THE SERENGETI

** SALES CENTER **

AT ATHERSTONE COMMUNITY
ANGIER, NORTH CAROLINA

PERMIT SET FOR CONSTRUCTION

FLOOR PLAN

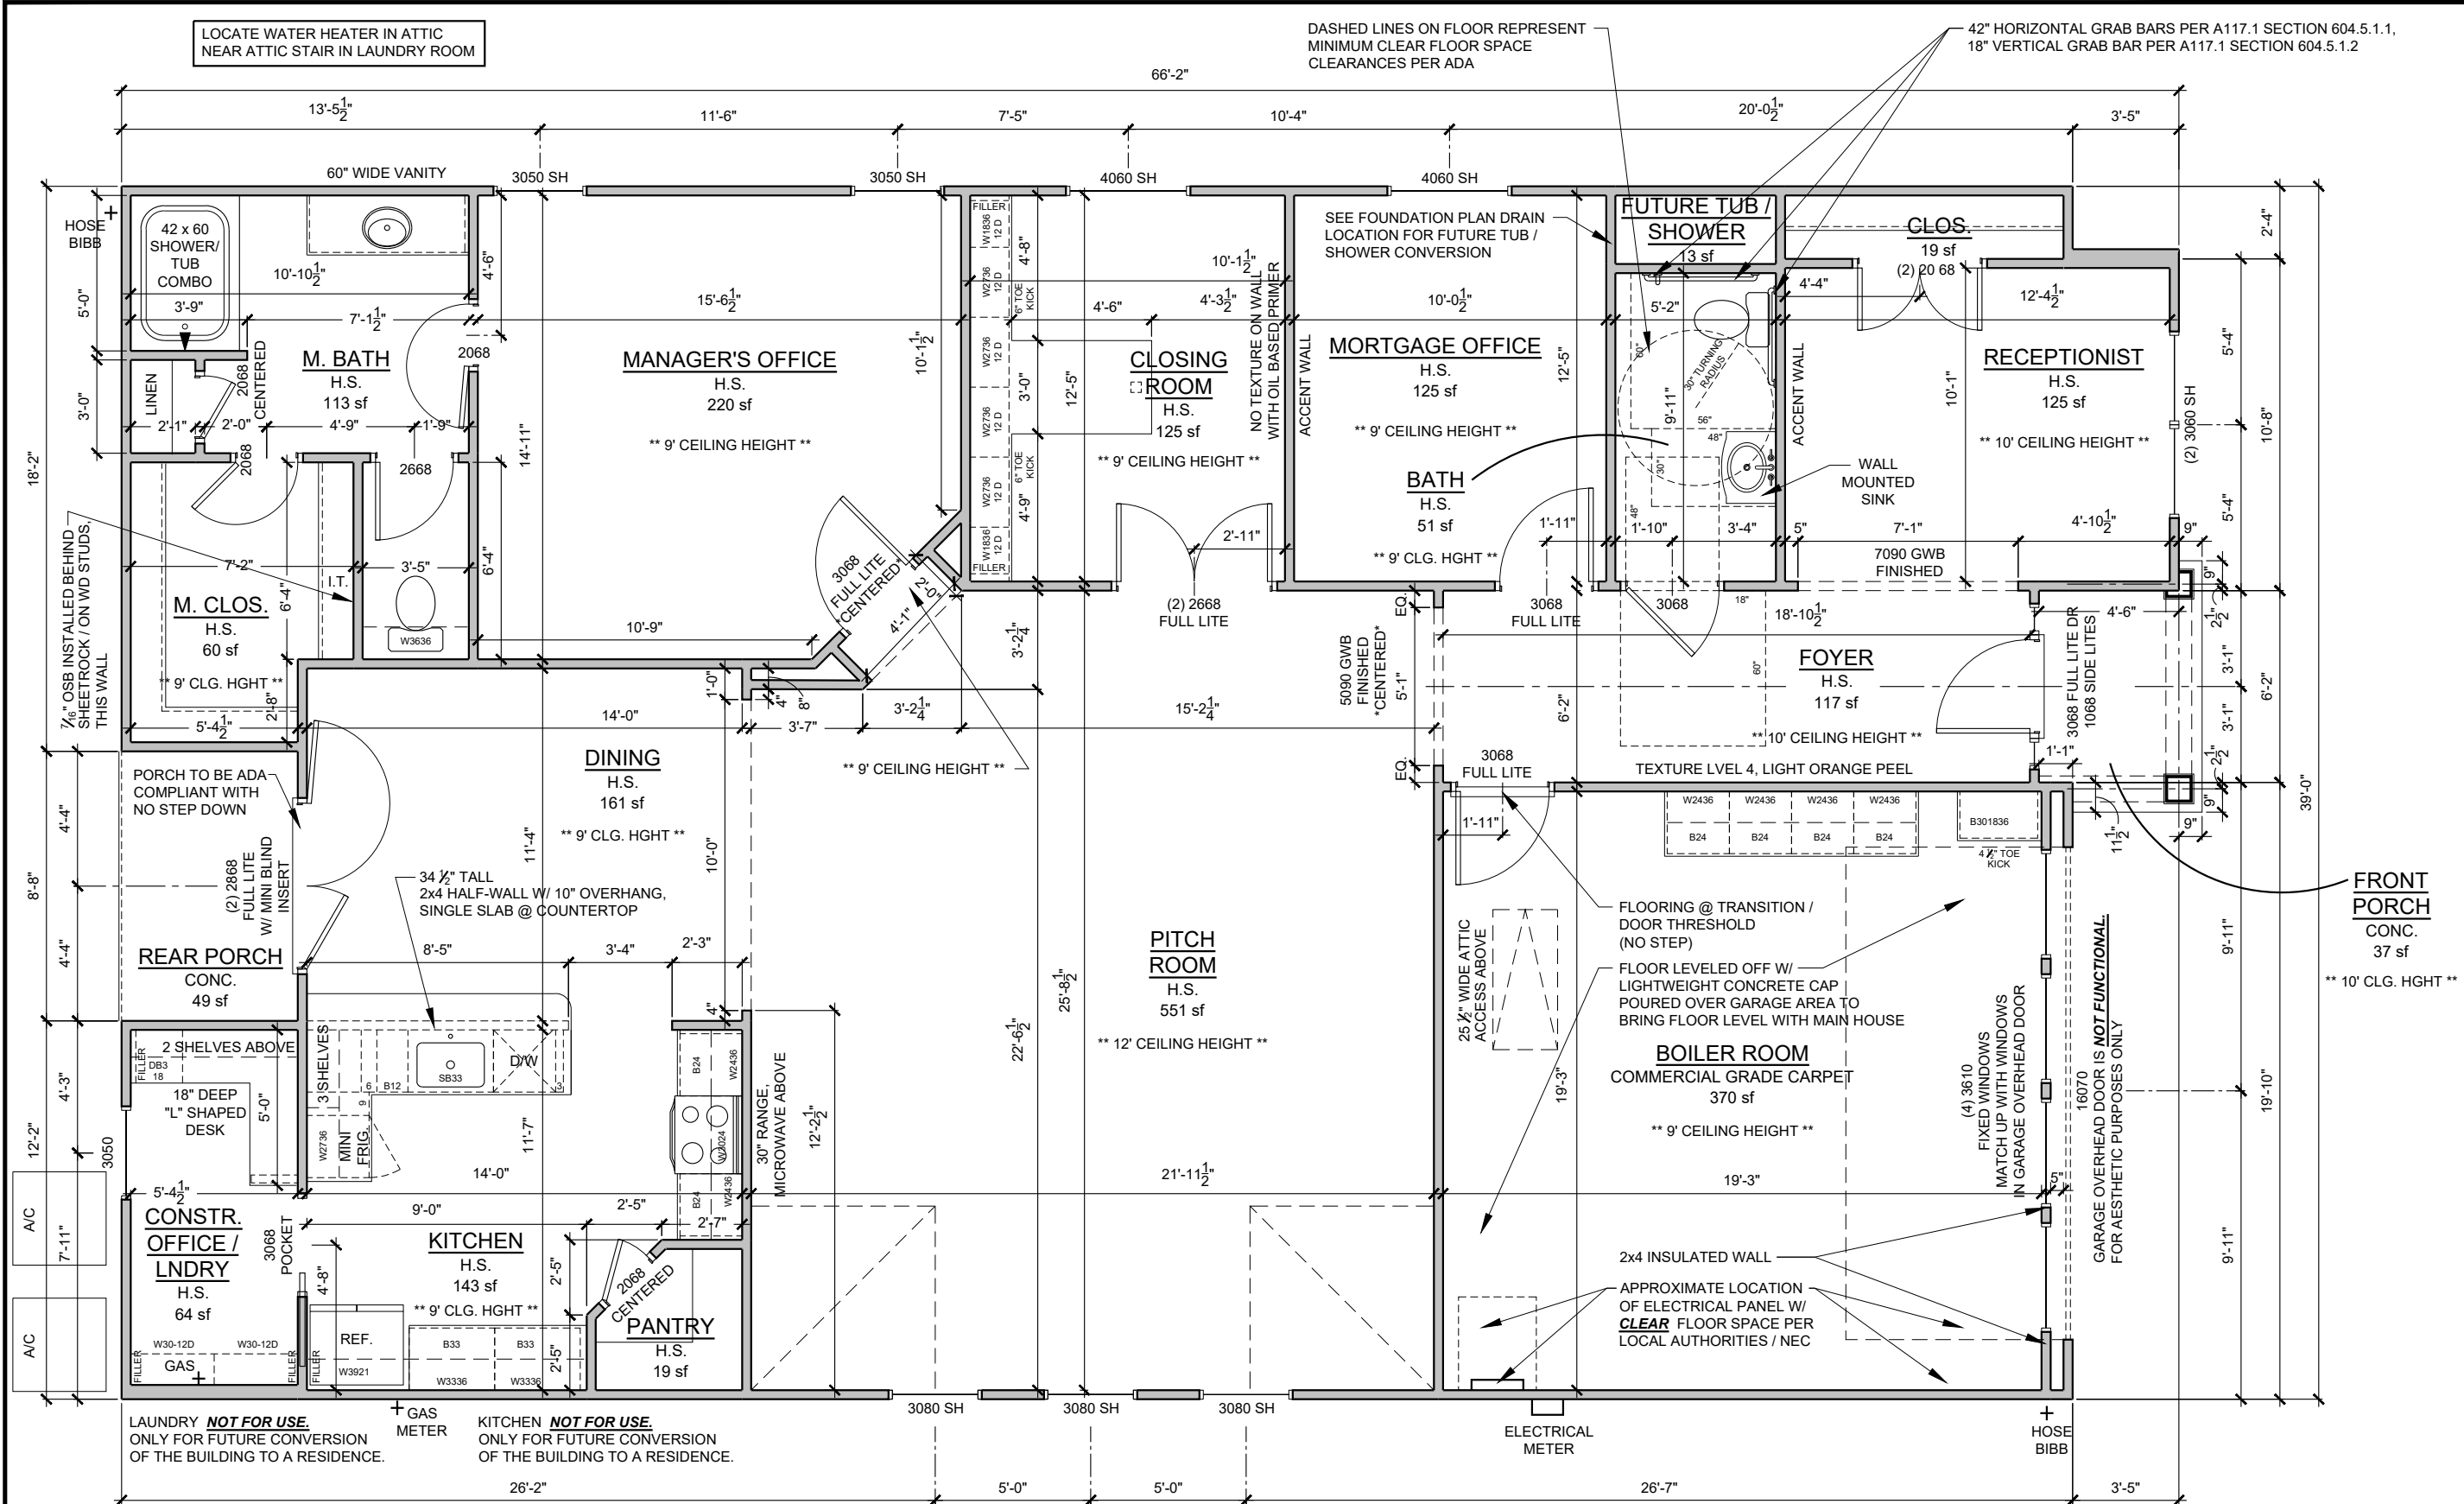
Sales office. Accessible parking to be located at the house, not across the street. Must have accessible route from parking through sales center/no step at front porch/entryway

LOCATE WATER HEATER IN ATTIC NEAR ATTIC STAIR IN LAUNDRY ROOM

DASHED LINES ON FLOOR REPRESENT MINIMUM CLEAR FLOOR SPACE CLEARANCES PER ADA

42" HORIZONTAL GRAB BARS PER A117.1 SECTION 604.5.1.1, 18" VERTICAL GRAB BAR PER A117.1 SECTION 604.5.1.2
